**3 Volt Intel[®] Advanced Boot
Block Flash Memory
28F004/400/008/800/
016/160/320/640B3 (x8/x16)**

Specification Update

April 2002

Order Number: 297948-012

2. Invalid Read Durations for CE# High Pulse Width

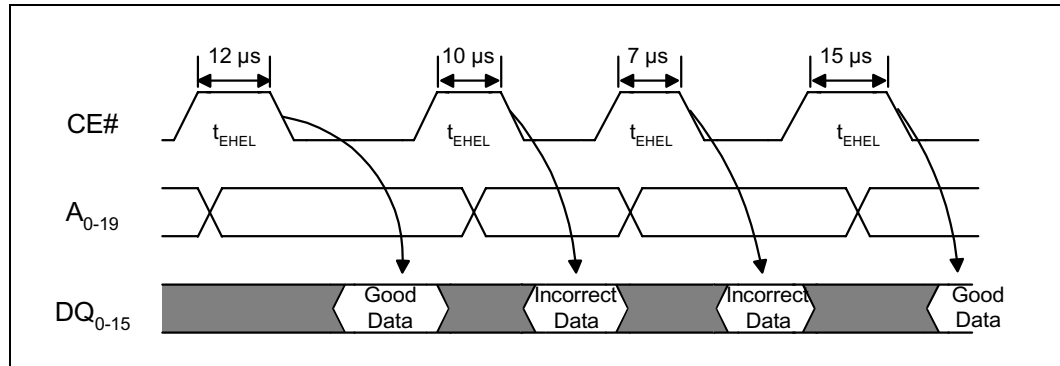
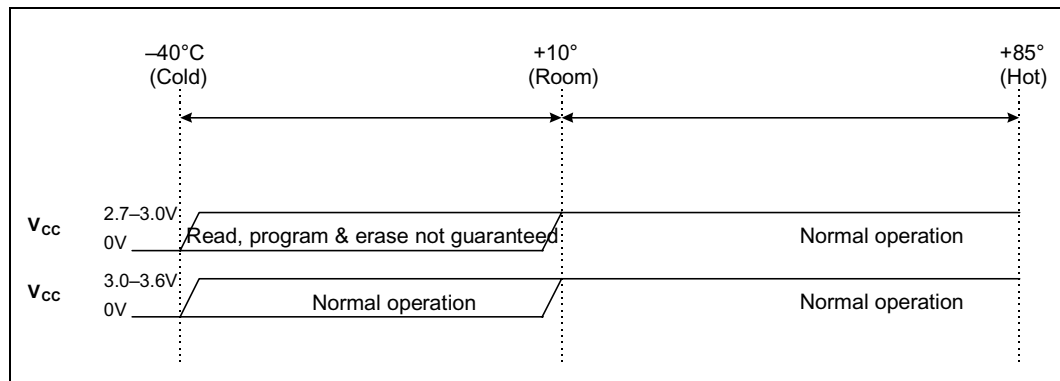
Problem: During consecutive read operations, CE# may be left low or toggled as desired. If CE# is toggled high (see diagram below) for 4 μs –11 μs between read operations, subsequent reads will return incorrect data.

Implication: If CE# is not toggled between consecutive reads, there is no impact. Any application that toggles CE# between read operations will be affected if the CE# high pulse width is within the nonfunctional range, i.e., 4 μs $\leq t_{\text{EHEL}} \leq 11 \mu\text{s}$.

Workaround: Either of the following actions will prevent this erratum:

1. Do not toggle CE# between consecutive read operations
2. Insure t_{EHEL} is less than 4 μs or greater than 11 μs

5. Maximum I_{CCD} Change

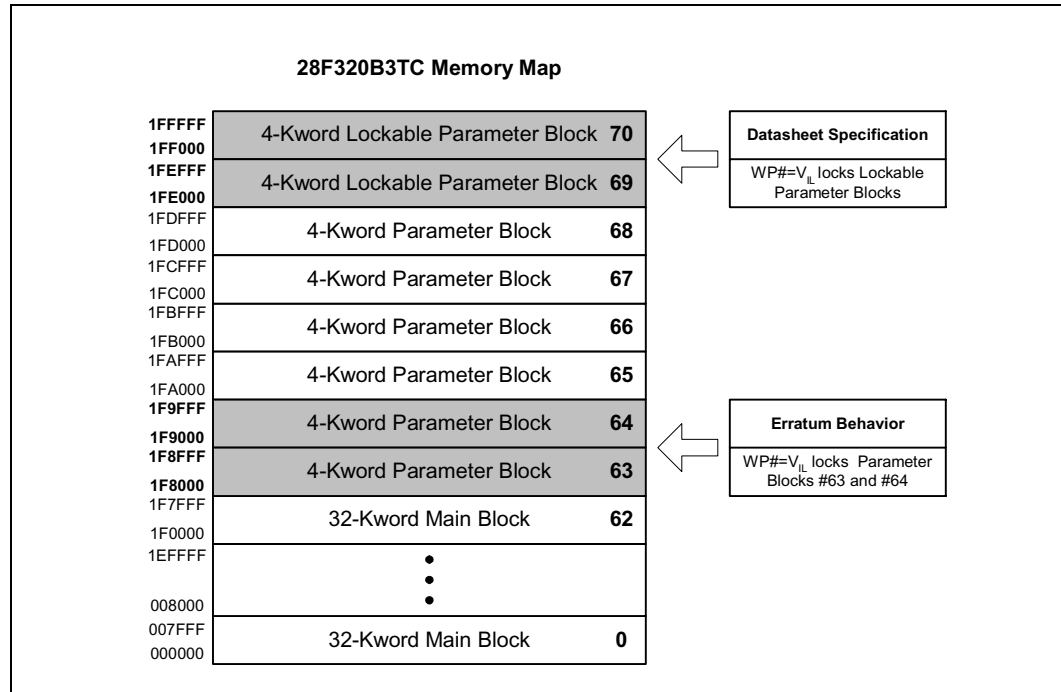
Problem: The maximum I_{CCD} increases from 20 μ A to 25 μ A. The following in the revised I_{CCD} specification:

Implication: The maximum I_{CCD} is specified under worst case conditions only ($V_{CC} = 3.6$ V, temperature = +85 °C). The typical I_{CCD} specification should be used to determine I_{CCD} current draw under typical conditions ($V_{CC} = 3.3$ V, temperature = +25 °C). The typical I_{CCD} specification has not changed.

7. 28F320B3xC Reset Failure

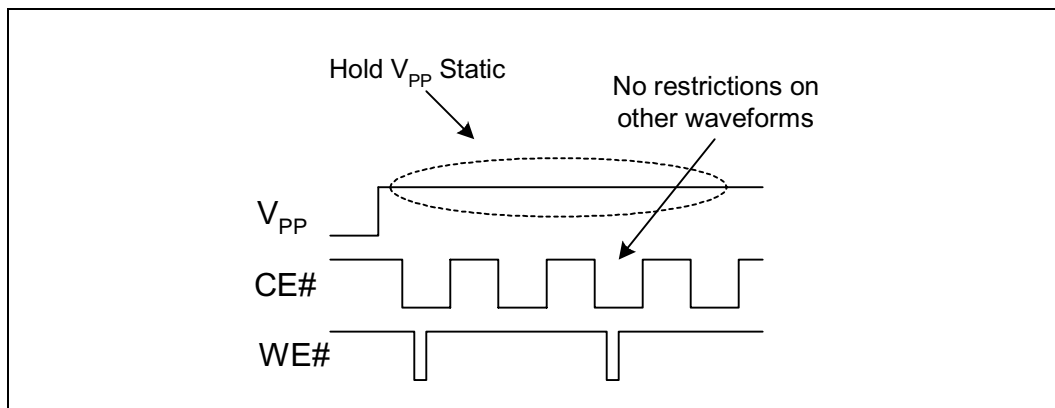
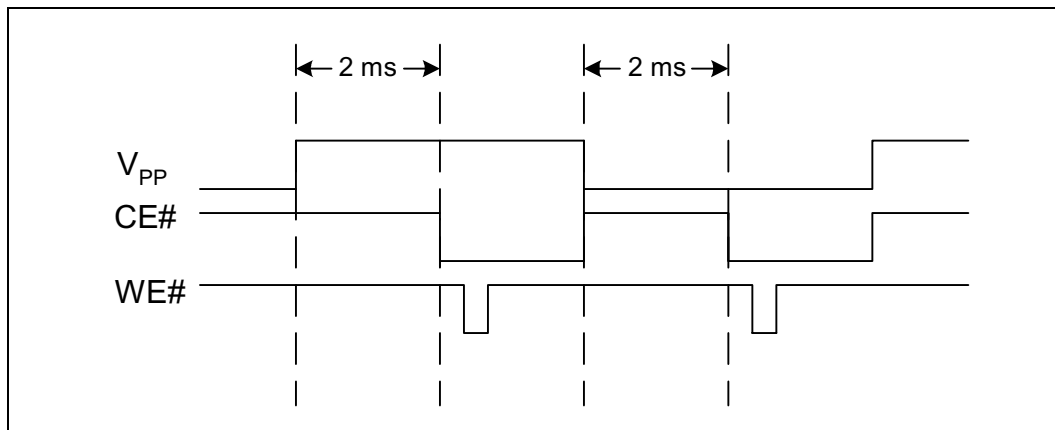
Problem: The 0.18 μ m 28F320B3xC devices can unintentionally reset under certain conditions where V_{PP} toggles.

Implication: When the reset occurs, any command being executed is interrupted and the flash switches to read array mode.

Workaround: There are four workarounds for this erratum:

- 1) Tie V_{PP} to V_{CC}
- 2) If the third and fourth digits on the top side FPO mark (third line) are equal or greater than “23”, then V_{CC} may be set from 2.7 V to 3.3 V. V_{CC} must not exceed 3.3 V.
- 3) Set V_{PP} to a static high or static low level as shown here; and

- 4) Wait 2 ms after a V_{PP} transition to access the flash device as shown here.

Figure 1. Workaround Placement

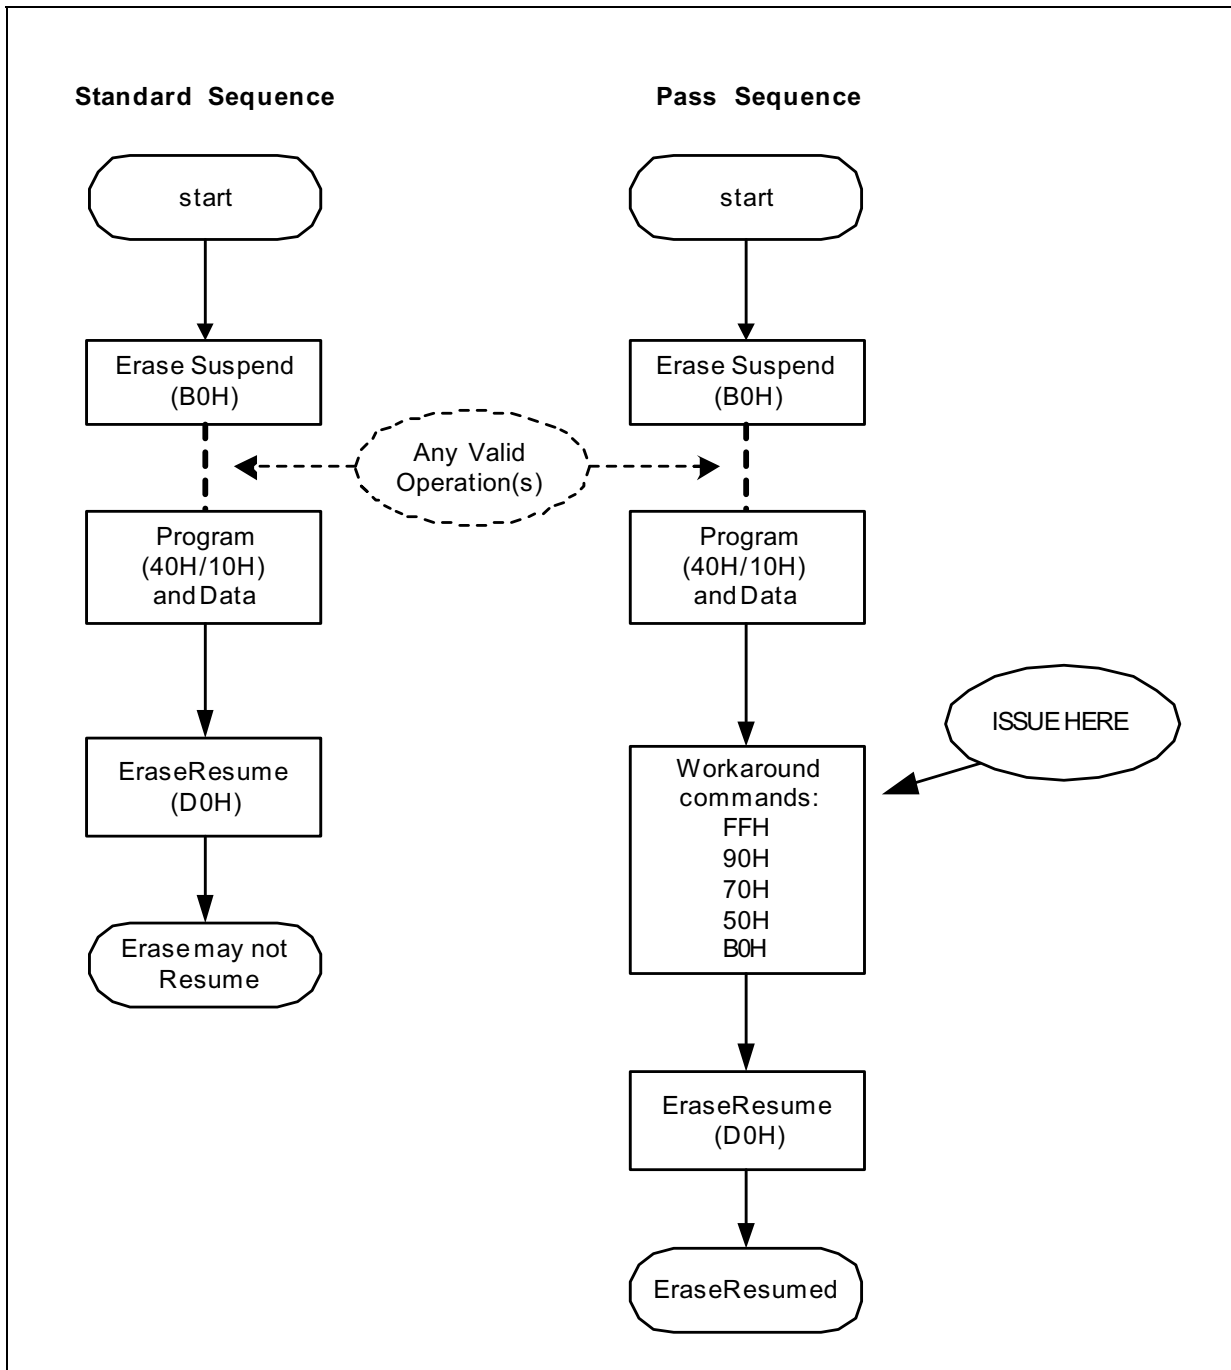
Problem: On the 0.18 μ m 28F160B3xC device, a design anomaly was discovered. During an Erase-Suspend operation, if the Program (40H/10H) sequence is executed, under limited conditions the proceeding Erase Resume command (D0H) may not actually resume the device. No customers have reported failures in product applications. Customers who use any version of FDI (Intel Flash Data Integrator) software will not see this issue. If the Read Array command is issued prior to the Erase Resume command, users will not see the issue (typical in XIP applications).

Implication: The Resume Command (D0H) may be ignored by the device and will not correctly resume. The device will appear to remain in suspend (via status register). After a reset of the flash device the status register will clear. This failure has been recreated in a lab environment only.

1. If FDI (Intel Flash Data Integrator) software is used, users will not see the issue.
2. During an Erase-Suspend (B0H), user must issue any of the following commands listed in Table-1 after issuing the Program (40H/10H) and data sequence but before issuing the Erase-Resume (D0H) command.
